App. No. 10/691,644

Indt. dated November 22, 2006

Reply to Office Action of June 23, 2006

Amendments to the Drawings:

FIG.1

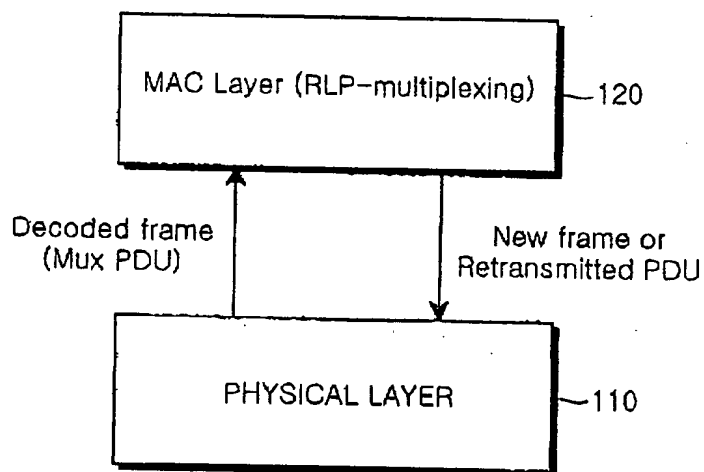
The attached sheets of drawings includes changes to drawing FIGs. 1-4 and replace the original sheets. Drawing figures 1, 3 and 4 have been amended to be designated by the legend of "Conventional Art." Drawing figure 2 has been amended to be designated by the legend of "Related Art."

In response to the Examiner's objection to the drawings the Applicants have amended drawings figures 1-4. Specifically, drawing figures 1, 3 and 4 as amended are designated by the legend of "Conventional Art." Drawing figure 2 as amended is designated by the legend of "Related Art." Accordingly, Applicants respectfully request withdrawal of the objection to the drawings.

(CONVENTIONAL ART)
